BID NO. 603812-15

TRAFFIC SIGNAL AND ROADWAY IMPROVEMENTS ON TROPICANA AVENUE
FROM LINDELL ROAD TO DECATUR BOULEVARD

ADDENDUM NO. 1

**TRAFFIC SIGNAL POLE WITH ILLUMINATED
 STREET NAME SIGN DETAIL**

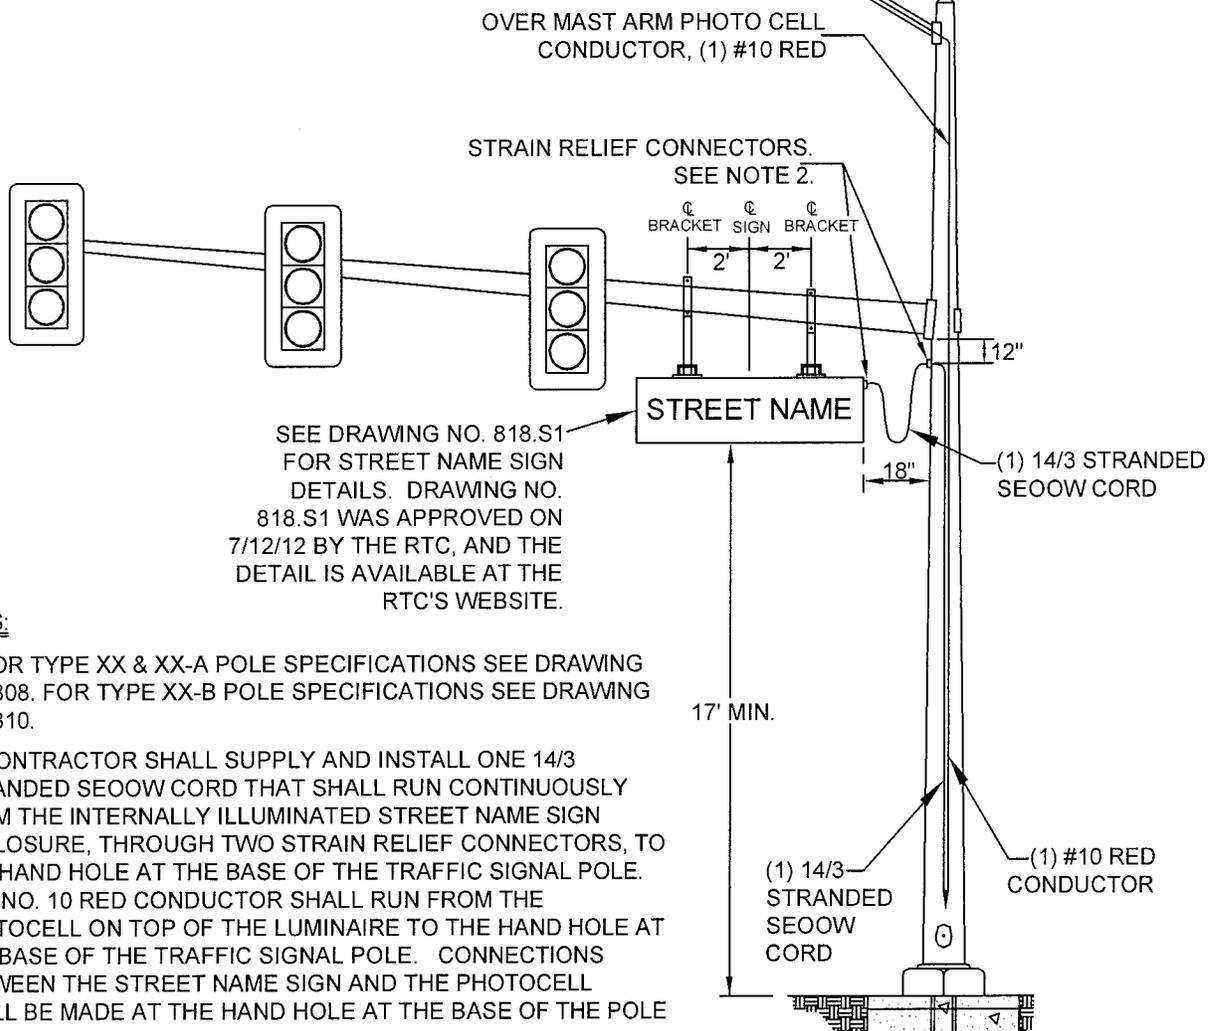
10. Sheet No. TA-4:

- a) **Add** Detail (see attached).

PHOTOCELL: STREET NAME SIGN
 POWER TO BE FED FROM AN
 ELECTRONIC PHOTOCELL DIRECTLY
 OVER MAST ARM AND TERMINATED AT
 BOTTOM OF POLE AT THE HANDHOLE.
 IF 20-FOOT HEIGHT TRAFFIC SIGNAL
 POLE IS USED, AN ELECTRONIC
 PHOTOCELL SHALL BE INSTALLED ON
 THE POLE CAP.

1. FOR TYPE XX & XX-A POLE SPECIFICATIONS SEE DRAWING NO. 808. FOR TYPE XX-B POLE SPECIFICATIONS SEE DRAWING NO. 810.
2. CONTRACTOR SHALL SUPPLY AND INSTALL ONE 14/3 STRANDED SEOWW CORD THAT SHALL RUN CONTINUOUSLY FROM THE INTERNALLY ILLUMINATED STREET NAME SIGN ENCLOSURE, THROUGH TWO STRAIN RELIEF CONNECTORS, TO THE HAND HOLE AT THE BASE OF THE TRAFFIC SIGNAL POLE. ONE NO. 10 RED CONDUCTOR SHALL RUN FROM THE PHOTOCELL ON TOP OF THE LUMINAIRE TO THE HAND HOLE AT THE BASE OF THE TRAFFIC SIGNAL POLE. CONNECTIONS BETWEEN THE STREET NAME SIGN AND THE PHOTOCELL SHALL BE MADE AT THE HAND HOLE AT THE BASE OF THE POLE

3. THE STRAIN RELIEF CONNECTORS SHALL BE STRAIGHT ALUMINIUM DELUXE CORD GRIP/STRAIN RELIEF CONNECTORS THAT ARE COMPATIBLE WITH A 0.005-INCH TO 0.625-INCH CORD DIAMETER. STRAIN RELIEF CONNECTOR SHALL BE HUBBELL F2 OR AN APPROVED EQUIVALENT BY THE TRAFFIC MANAGER.

4. THE SEOWW CORD SHALL HAVE THREE (3) NO. 14 AWG CONDUCTORS (BLACK, GREEN AND WHITE), AND HAVE THERMOPLASTIC ELASTOMER (TPE) INSULATION AND THERMOPLASTIC ELASTOMER (TPE) JACKET. THE SEOWW CORD SHALL BE WATER-RESISTANT, UL LISTED, RATED FOR 600 VOLTS, WITH TEMPERATURE RANGE FROM 105 DEGREES CELSIUS TO -50 DEGREES CELSIUS. SEOWW CORD SHALL BE CCI SEOPRENE 105 14 AWG 3/C SEOWW E54864 OR AN APPROVED EQUIVALENT BY THE TRAFFIC MANAGER.
